California Regional Water Quality Control Board

ENROLLMENT OF NTMP# 1-06NTMP-017 SCR - LITTLE BUCK UNDER ORDER NO. R3-2005-0066 THE GENERAL CONDITIONAL WAIVER OF WASTE DISCHARGE REQUIREMENTS - TIMBER HARVEST ACTIVITIES IN THE CENTRAL COAST REGION

Re: Preharvest Inspection of Nonindustrial Timber Management Plan
1-06NTMP-017 SCR Little Buck

RECOMMENDATIONS

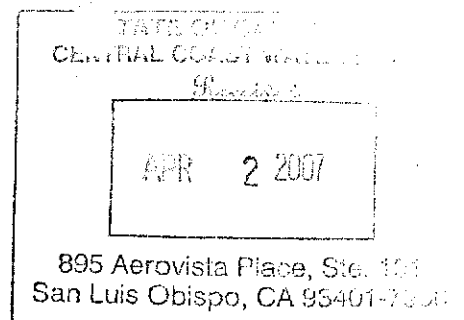
AT PWA Site #25:

- Add a trash rack per the specifications of the Geotechnical Engineer – John Kasunich upstream of the crossing.
- Monitor and maintain the site until the MRP is rescinded. The Deer Creek Road Association, including the landowner of the site, will assume responsibility for monitoring and maintenance of the crossing after the MRP is rescinded.
- Install gabion baskets constructed of rust resistant galvanized metal.
- Install and anchor the gabion baskets on the hinge-line of the road fill and native soil and anchor all the gabion baskets into solid earth.
- Stabilize the gabion baskets with 1" rebar.
- Modify the drainage structure of the road currently discharging to the destabilized fill material. Redirect road runoff from discharging at the currently unstable location by installing a critical dip north of the gabion baskets.
